Lobell  
Rubin

## Responses to COV Technical Review Comments – Village at Laurel & Jacaranda

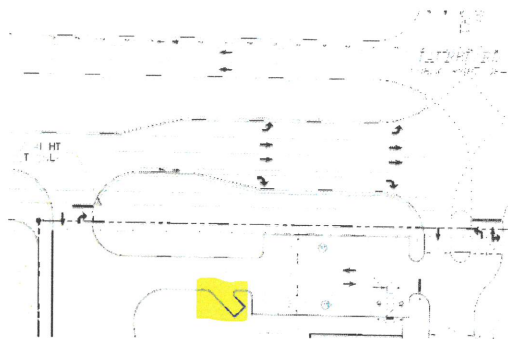
9. Please label the area that is cut out just south of the retail building on the east side of the site and the area in the northwest corner shown here:

**Please see updated site plans.**
